MONTICELLO

PROPOSED CHANGE TO TECH SPECS RE
THE REACTOR PROTECTION SYSTEM

MONTICELLO NUCLEAR GENERATING PLANT

License Amendment Request Dated February 14, 1992

Exhibit A
Figure A-1

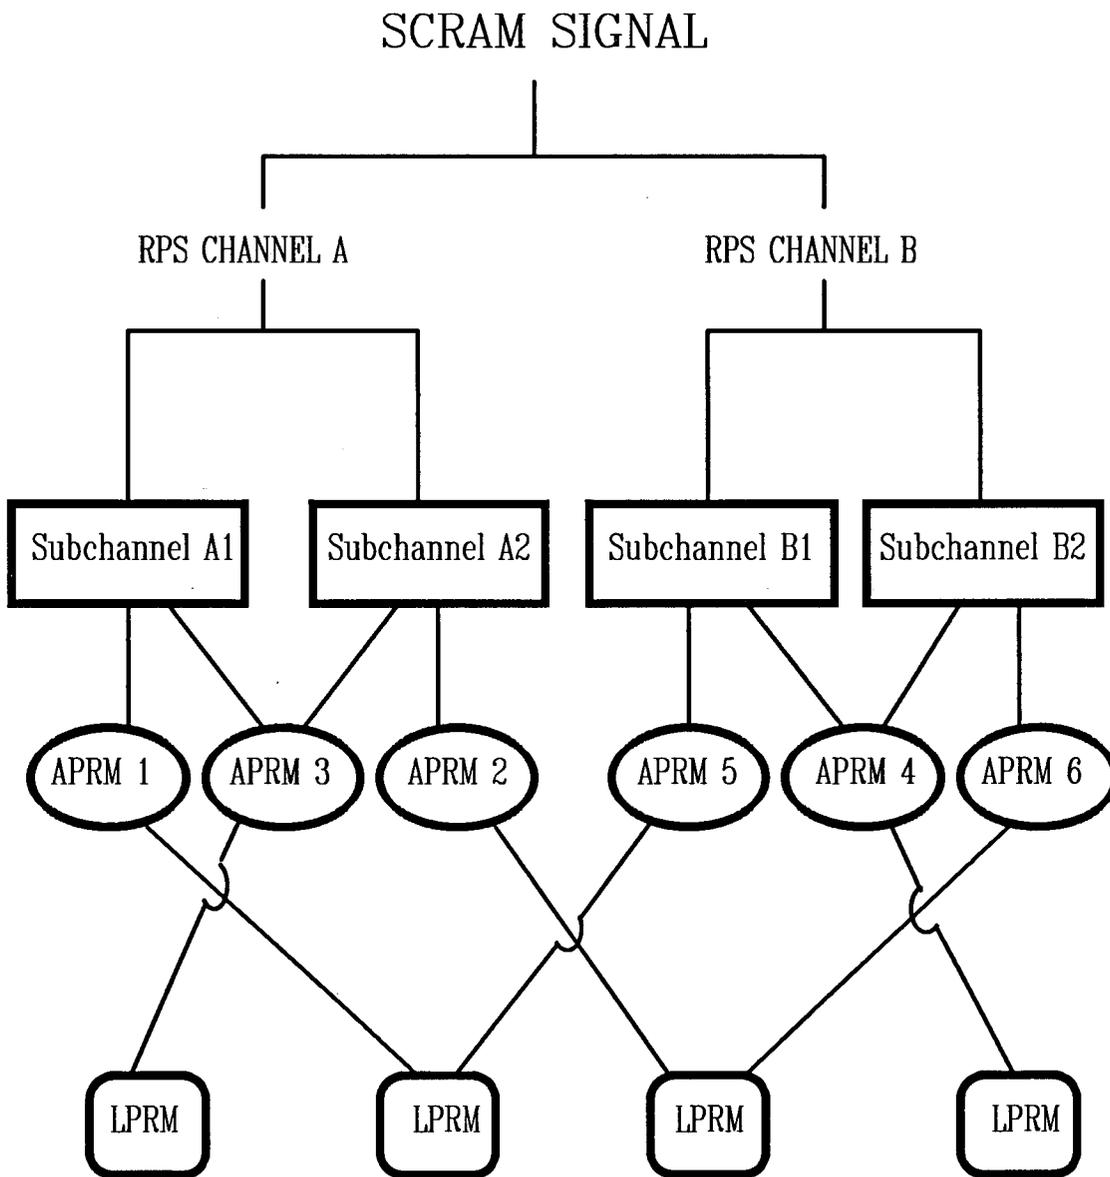
Monticello was designed and constructed to have 2 Reactor Protection System primary channels (A & B), with each channel further divided into 2 subchannels to provide a 1-out-of-2-twice scram logic. Each subchannel receives inputs from a dedicated Average Power Range Monitor. In addition, each primary channel is served by a third Average Power Range Monitor that is connected to both subchannels. This third Average Power Range Monitor serves, in effect, as an installed spare and is used to maintain the 1-out-of-2-twice logic when one of the other Average Power Range Monitors becomes inoperable or is removed from service for other reasons. To facilitate this, each primary channel is provided with a joystick type switch that permits bypass of one (but only one) Average Power Range Monitor. Refer to Figure A-1 for a simplified diagram of the Average Power Range Monitor scram logic.

The Reactor Protection System is also configured such that some Average Power Range Monitors in channel A share Local Power Range Monitor inputs with Average Power Range Monitors in channel B. Specifically, Average Power Range Monitor 1 (Channel A) receives input from the same Local Power Range Monitors as Average Power Range Monitor 5 (Channel B). Similarly, Average Power Range Monitor 2 (Channel A) receives input from the same Local Power Range Monitors as Average Power Range Monitor 6 (Channel B). As a result, a single Local Power Range Monitor failure could trip both channels of the Reactor Protection System and cause a scram. This has happened twice at Monticello (scram #53 on July 27, 1978 and scram #55 on August 24, 1978). For this reason, unless otherwise needed, one Average Power Range Monitor per primary channel (Average Power Range Monitors 2 & 5, or 1 & 6) is bypassed during normal operation to preclude unnecessary scrams.

The current 3.1 Bases wording could be construed as being all inclusive, implying that the only permissible reasons for bypassing an Average Power Range Monitor are those listed (i.e. for maintenance, testing or calibration). In fact, there are other valid reasons for bypassing an Average Power Range Monitor, such as the case described above, and the system is designed to accommodate these situations. The proposed change to the Technical Specification 3.1 Basis section is intended to clarify that Average Power Range Monitor bypasses need not be limited to the situations currently listed and are acceptable in other cases provided Technical Specification requirements regarding the minimum number of operable channels are maintained.

<u>Page</u>	<u>Section</u>	<u>Proposed Change</u>
36	3.1 Bases	Revise fifth sentence of first paragraph to read: "This allows the bypassing of one APRM per protection trip system."
